Subject: Duke Energy
Oconee Nuclear Station, Unit 1, 2, and 3
Docket No. 50-269,-270,-387
Third Ten Year Inservice Inspection Interval
Request for Relief No. 04-ON-006

Proposed Relief in Accordance with 10 CFR 50.55a (a)(3)(ii)**Inservice Inspection Hardship****Duke Energy Corporation**

Third 10-Year Interval – Inservice Inspection Plan**ASME Section XI Code – 1989 Edition with No Addenda**

See Attachment A for a drawing on F01040 support area/weld locations.

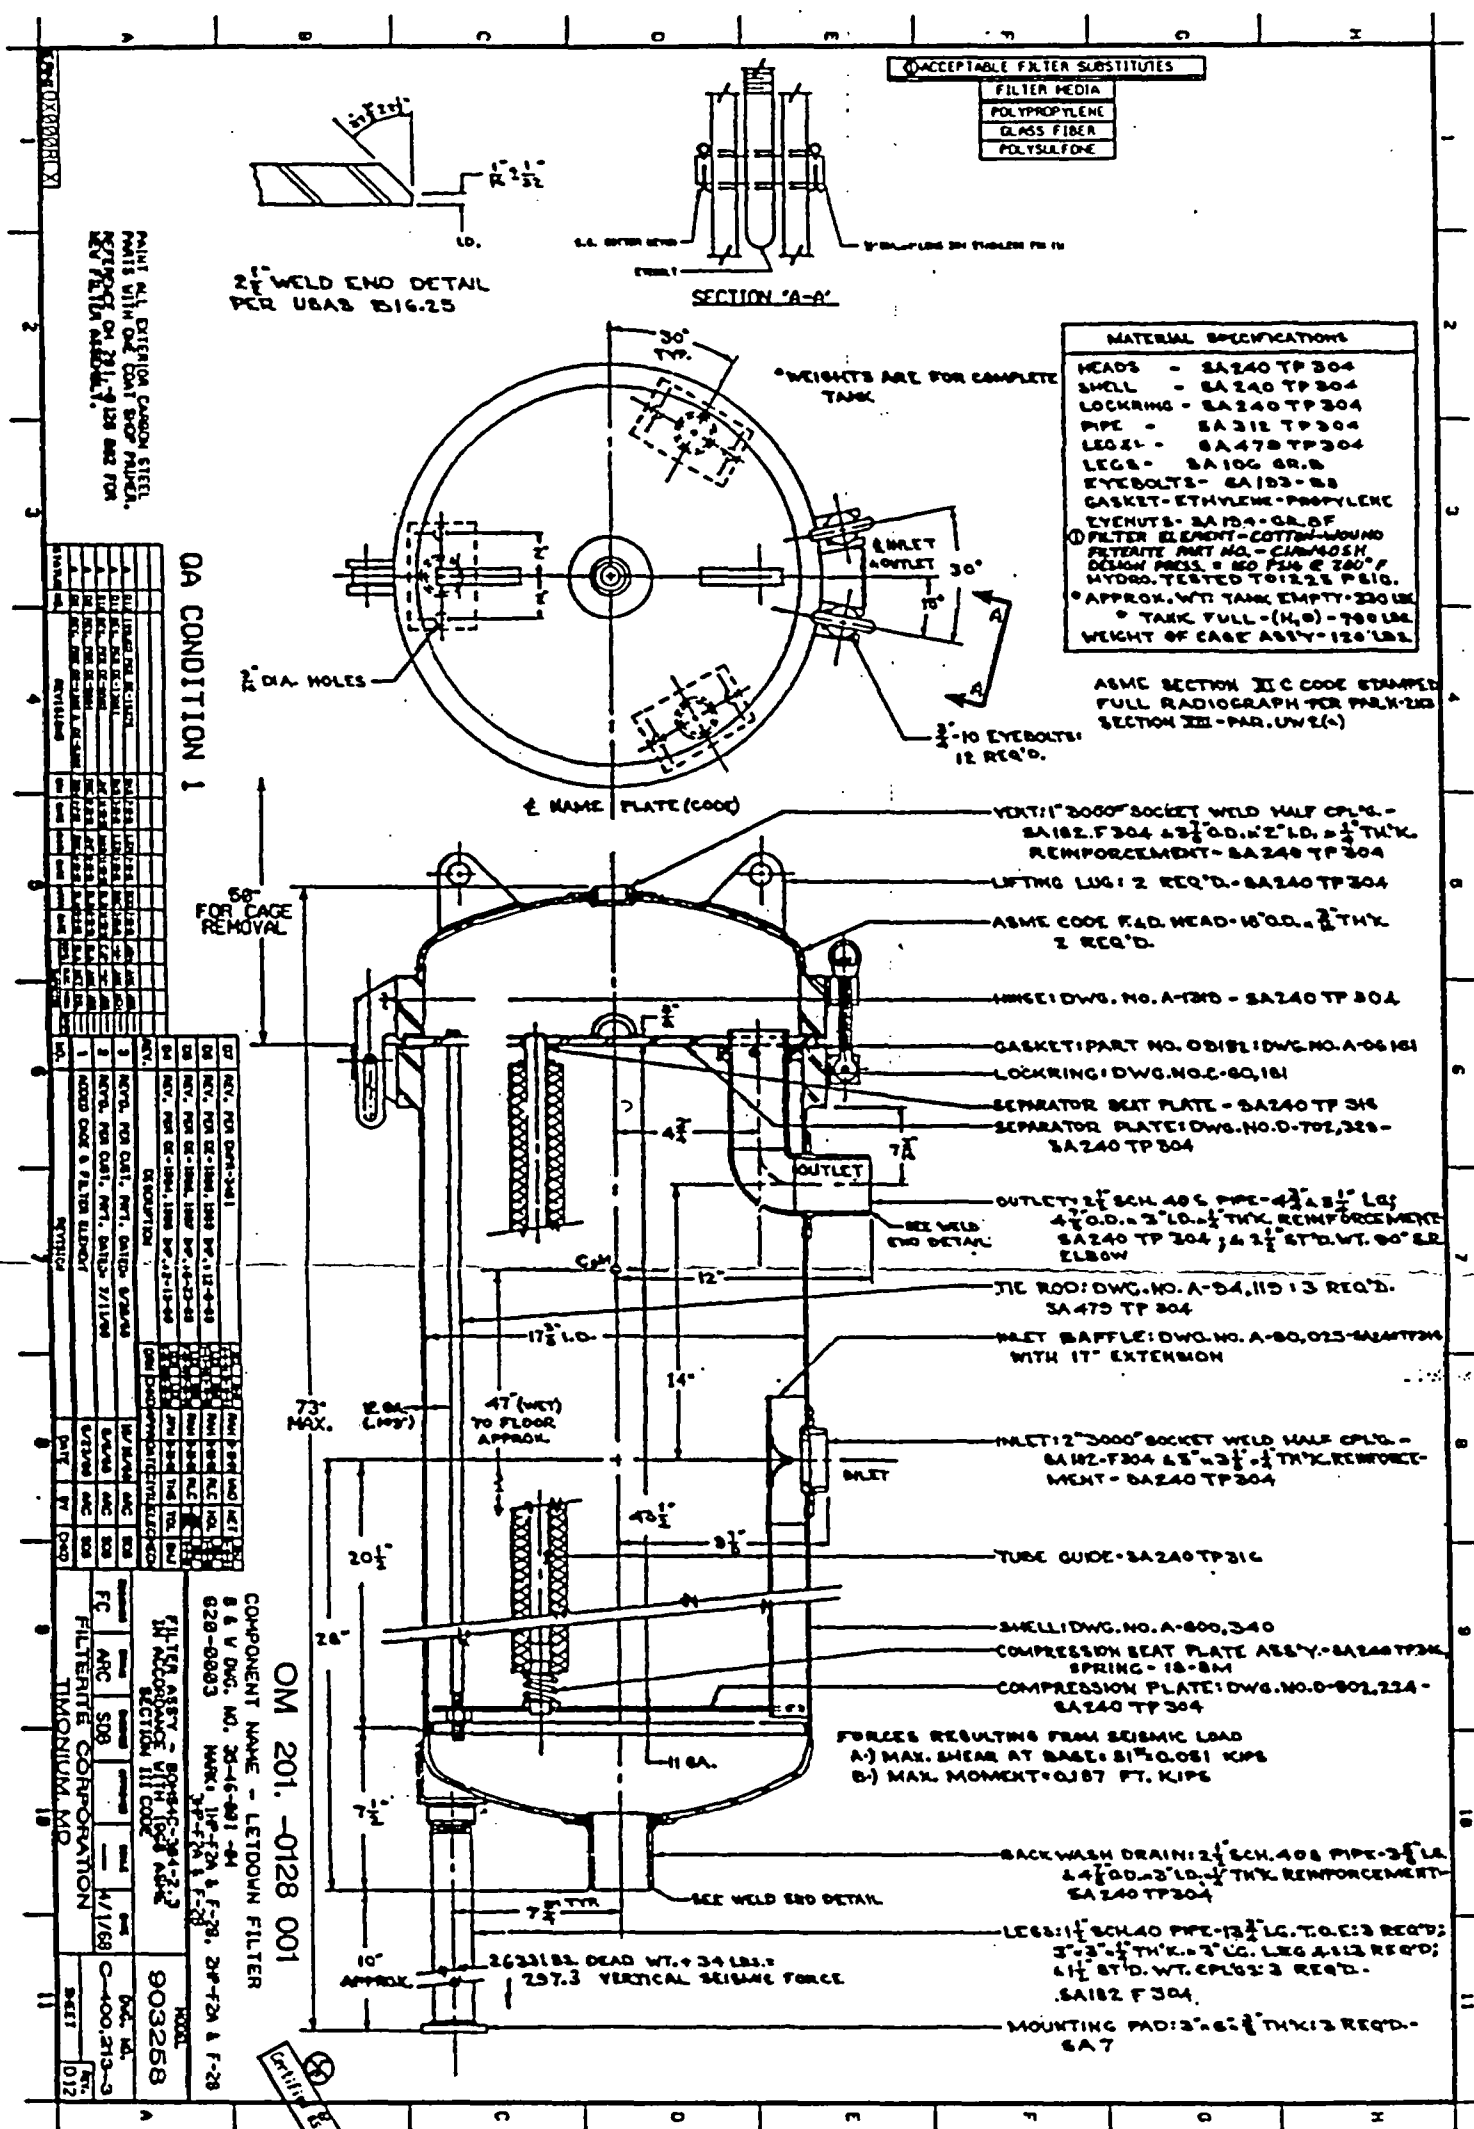
During the remote visual examination of the Letdown Filter Housing support (Item F01.040.035), the examination was limited because portions of the support were covered by insulation and the inspection was performed using a camera mounted to an extendable boom which limited viewing portions of the inspection area. The room could not be entered into by personnel to inspect or remove the insulation due to it being in a highly contaminated area and it is also an area that may have asbestos concerns. RP states that the most recent encounter with insulation in this area resulted in airborne activity measuring 19.6 DAC (beta /gamma) and 130 DAC (alpha). It would take considerable effort of changing the installed filters and decon efforts to get the whole body exposure rates to a manageable range (100 mr/hr general area).

The dose received to perform the remote inspection that was performed by QC and civil engineering was 0 mrem. The dose (1.050 rem) that would be received to prepare the Letdown Filter Housing support so that 100% of the support could be examined would be a hardship for Duke Energy. There were no indications found that would cause the support to be inoperable, on the areas of the support that were examined.

Support No. 1-LDFLTR-1A-HOUSING SUPPORT
QA Item No. F01.040.035

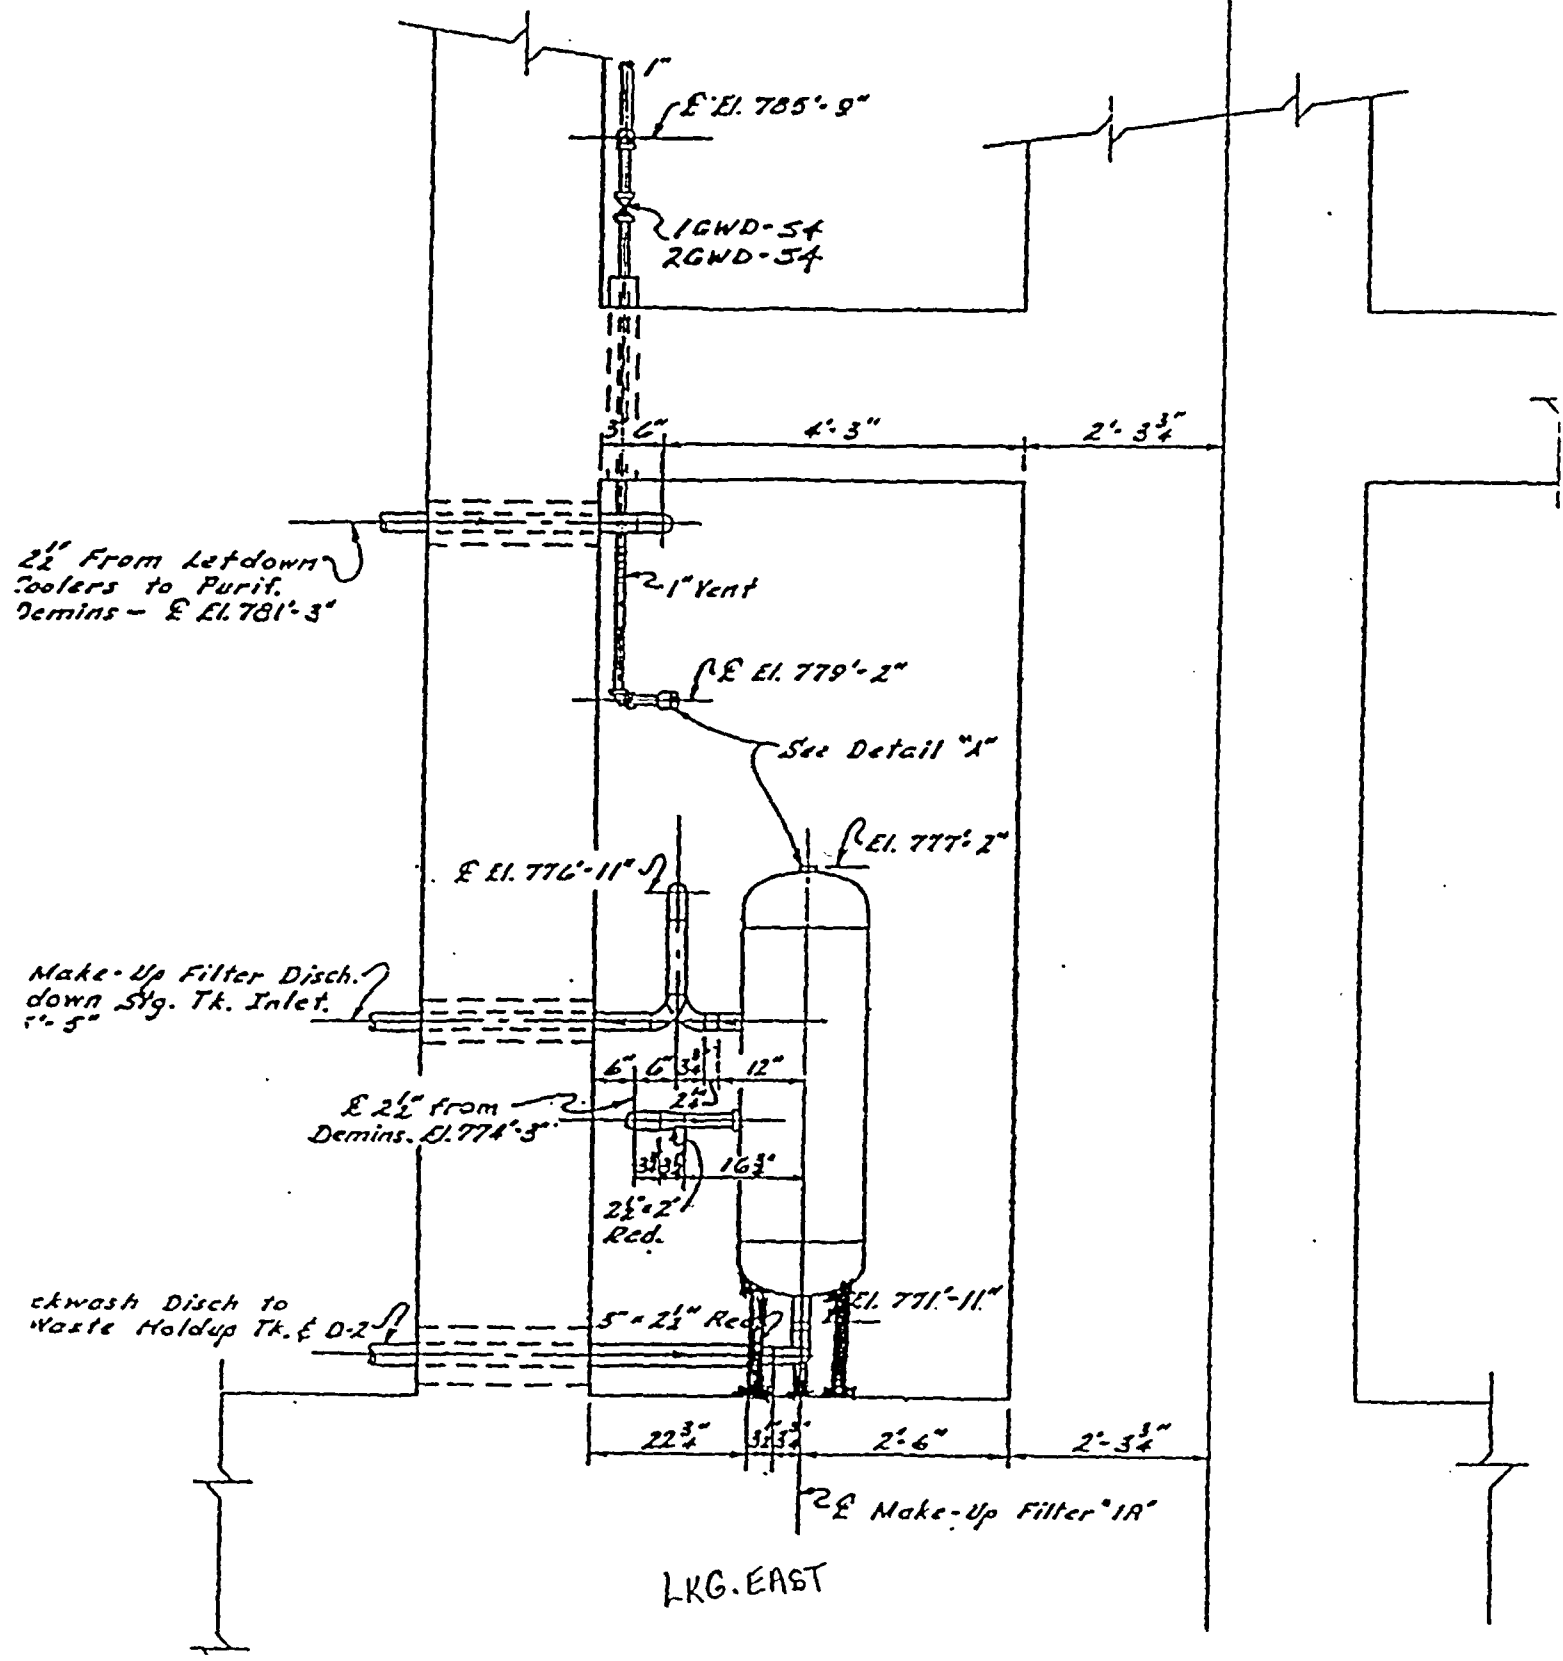
CAMERA LOWERED FROM HATCH ABOVE - INSULATION COVERED PART OF ANGLES TO TANK - LEGS SOUTHEAST, NORTH, WEST, LEGS VISIBLE - BASE PLATES VISIBLE - EVERYTHING ELSE NOT LOOKED AT - PARTIALLY

"Using a RP camera mounted on an extendable boom, VT-3 of the support posts and their anchorage for 1A & 1B Letdown Filter Housing was performed. The filter housing is insulated, covering parts of the legs under the housing. With lighting on the camera, QC was able to see a portion of the legs and the base plates/anchors. There has been some leakage in the past during filter changes. This has caused some surface rust but not bad enough to have buckled paint. This is a limited inspection. However, QC feels that the overall condition of the support is good."

Civil engineering also observed/inspected the support posts and their anchorage for 1A & 1B Letdown Filter Housing along with the QC inspectors in aux. bldg. unit-1. Since the filter housing is insulated covering parts of the legs under the housing, some visibility of the support legs and the anchorage is restricted due to limited access. Based on what was seen during inspection using the RP camera with lighting mounted on an extendable boom, the support legs, base plates and anchor bolts do not appear to have any degradation or damage that could raise a concern about its structural integrity besides some minor surface rust as reported. However, a Request For Relief for 1A & 1B Letdown Filter Housing needs to be processed since the complete inspection can not be performed.

Civil Engineering evaluated the support posts and their anchorage for 1A & 1B Letdown Filter Housing for the reported discrepancies per acceptance requirements of Code Case N-491, section 3122.3. The conclusions and recommendations are as follows:
